ZONING AMENDMENT,
PLANNED UNIT DEVELOPMENT &
SUBDIVISION STAFF REPORT

Date: November 16, 2006

<u>NAME</u>	Bay Yacht Condominiums
<u>SUBDIVISION NAME</u>	Bay Yacht Sales Subdivision
<u>LOCATION</u>	4700 Dauphin Island Parkway (West side of Dauphin Island Parkway, 1,000'+ South of Alba Avenue)
<u>CITY COUNCIL DISTRICT</u>	District 4
<u>PRESENT ZONING</u>	R-1, Single-Family Residential
<u>PROPOSED ZONING</u>	R-3, Multi-Family Residential B-3, Community Business
<u>AREA OF PROPERTY</u>	2 Lots/11.0± Acres
<u>CONTEMPLATED USE</u>	Rezoning from R-1, Single-Family Residential district, to R-3, Multi-Family Residential district, to allow four single- family residential condominium units. Rezoning from R-1, Single-Family Residential district, to B-3, community Business, to bring an existing marina into compliance. Planned Unit Development Approval to allow four single- family residential condominium buildings on a single building site. It should be noted, however, that any use permitted in the proposed district would be allowed at this location if the zoning is changed. Furthermore, the Planning Commission may consider zoning classifications other than that sought by the applicant for this

SITE PLAN

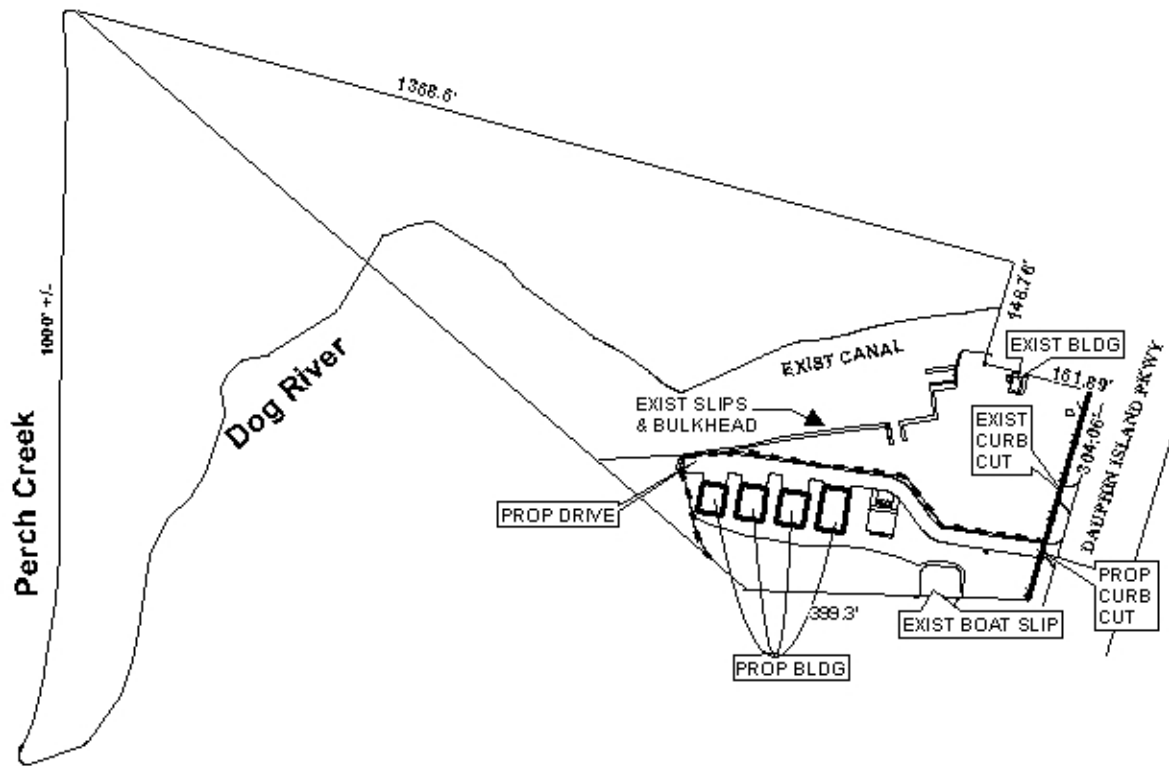
Conceptually, the development depicted on the proposed site/layout plan does not minimize impacts to the surrounding commercial development, especially with the proposed 30-foot building setback along the sides and rear boundary of the site. It should be noted that the access drive into the R-3 site is less than the required 24-foot. Additionally, it should be noted that there is no indication on the site plan regarding the perimeter treatment of the property; since this development would be adjacent to commercial districts, no buffer would be required of the R-3, Multi-Family development. Furthermore, generalized landscaping proposed for the common areas should be depicted on the site plan, with the understanding that final landscape plan will be more detailed and require approval by the Urban Forester.

A detention basin may be required for the site. A note should be placed on the site plan, if approved, stating that maintenance of the detention basin common area, and any other common areas, are the responsibility of the development’s property owners.

Finally, the minimum building setback line required in Section V.D.9. of the Subdivision Regulations is not shown for the overall lot, but would be required on the Final Plat.

Planned Unit Development: Based on the preceding, this application is recommended for approval, subject to the following conditions: 1) full compliance with the landscaping and tree planting requirements of the Ordinance for Lot 2; 2) the completion of the Subdivision process; and 3) full compliance with all municipal codes and ordinances.

SUBDIVISION AND ZONING DETAIL

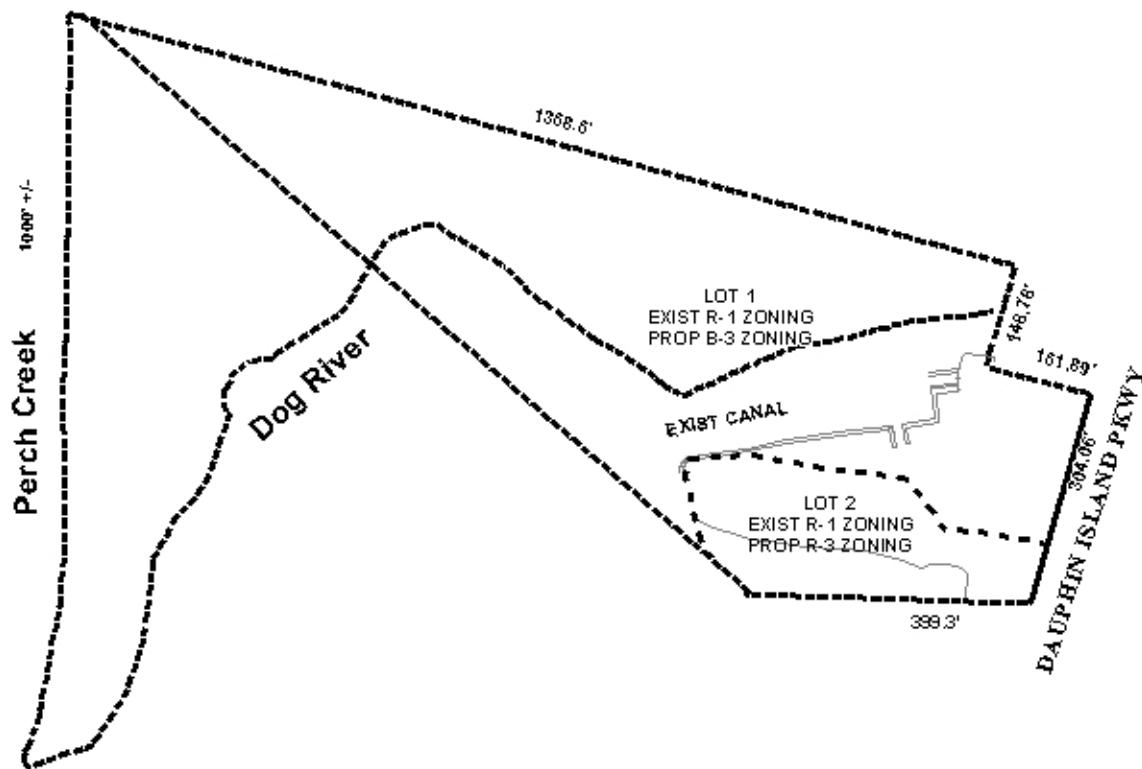
<u>TIME SCHEDULE FOR DEVELOPMENT</u>	Immediately
<u>ENGINEERING COMMENTS</u>	Show limits of flood zone on plat and label. Show minimum finished floor elevation on each lot. The applicant is responsible for verifying if the site contains wetlands. The site can be checked against the National Wetlands Inventory on the

The site in question is a non-conforming marina zoned R-1, Single-Family Residential. The applicant proposes to create two legal lots of record. Lot 1 will become B-3, Community Business, which will bring the marina into zoning compliance. Lot 2 as proposed requires the rezoning to R-3, Multi-Family Residential to accommodate four single-family dwelling units as condominiums. The site plan depicts four “buildings” that will be separated from each other by a minimum of 20-feet, and all “buildings” will be a minimum of 270-feet from the front property line, 30-feet from the side property lines, and 30-feet from rear property line.

The site fronts Dauphin Island Parkway, a major street with variable right-of-way. However, the Major Street Plan requires that the right-of-way be 100-feet. Therefore, the dedication of right-of-way sufficient to provide 50-feet as measured from the centerline of Dauphin Island Parkway, should be required.

Subdivision: The plat meets the minimum requirements of the Subdivision Regulations and is recommended for Tentative Approval with the following conditions: 1) the dedication of sufficient right-of-way to provide 50-feet as measured from the centerline of Dauphin Island Parkway; 2) placement of a note on the Final Plat stating that each Lot is limited to one curb-cut onto Dauphin Island Parkway, with the size, design and location of all curb-cuts to be approved by the Traffic Engineering Department and ALDOT; 3) a note be placed on the final plat limiting curb cuts to the approved Planned Unit Development; 4) the approval of all necessary federal, state and local agencies prior to the issuance of any permits or commencement of any Land Disturbing activities; and 5) the placement of the 25-foot minimum building setbacks on the final plat.
